ENGINEERING CHANGE NOTICE # 3

SHEET # 1
MARCH 1966

DWG 1-10.001 - MAIN SPAR - WING

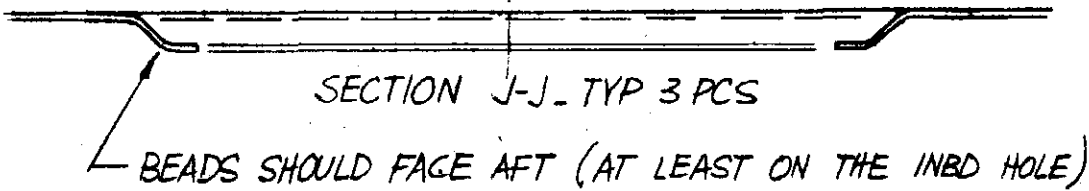
CHANGE TO AVOID INTERFERENCE WITH AILERON CONTROL
BELLCRANK

DWG 1-20.003 - STABILATOR - EMPENAGE -
LENGTH OF ALUMINUM PLUG WAS 1.00
SHOULD BE 1.25

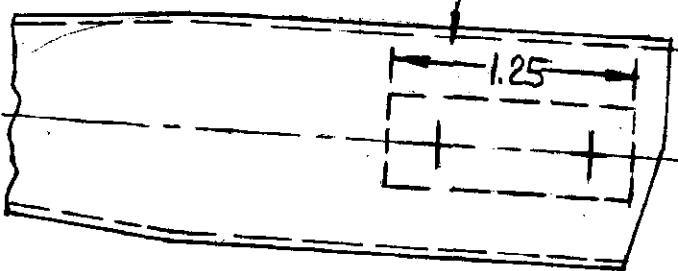
C-C
(CORRECT ERROR)

(IMPROVE DESIGN)

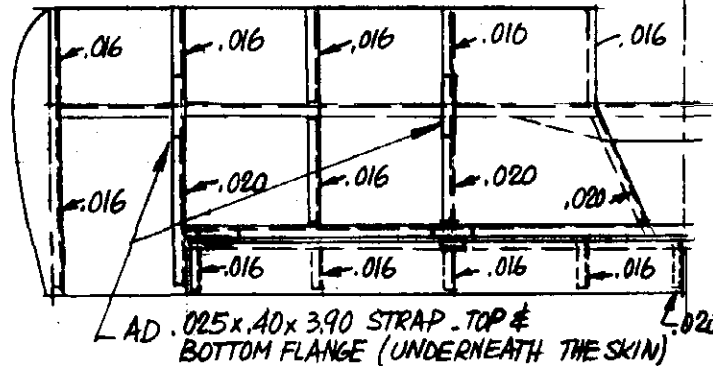
RIB THICKNESS - IF YOU DID NOT BUILT YOUR STABILATOR
YET. CORRECT YOUR DRAWING AS SHOWN.
IF YOU BUILT THE STABILATOR ALLREADY LEAVE IT AS
IS. NOTICE THAT WITH NEW THICKNESSES. ALL RIBS
HAVE LIGHTENING HOLES.
